#### INSPECTION REPORT: KENSINGTON GOLD MINE

Date of Inspection: Wednesday, May 11, 2022
Date of Report: Thursday, May 26, 2022

\*This inspection was conducted in part to comply with the requirement of the Plan of Operations Amendment 1 (POA1) Record of Decision (ROD) signed February 24, 2022, to conduct quarterly BMP-focused inspections. This inspection was completed with a focus on the condition and functionality of stormwater and sediment control BMPs following the winter season, when those features are commonly in need of repair and in a stressed condition following snow removal activities and spring snow melt.

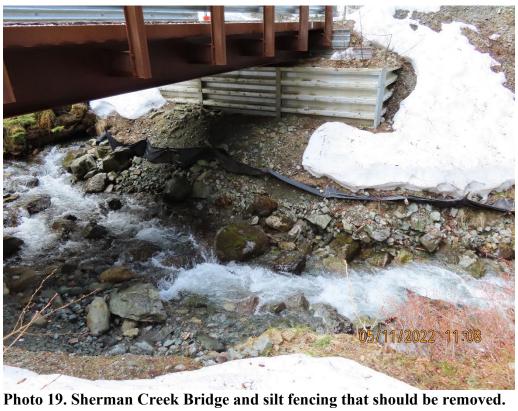
**NEW ACTION ITEM 189-2:** Silt fencing is present at both bridges (Photos 18-19). This fencing was installed during construction activities to reduce fine sediment discharge to the streams. The stream banks appear stabilized and/or revegetated to the extent that the silt fencing no longer serves a beneficial purpose and could become of source of debris if left in place. The silt fencing should be removed and disposed of.

**NEW ACTION ITEM 189-2:** Silt fencing below the No Name Creek and Upper Sherman Creek bridges should be removed.
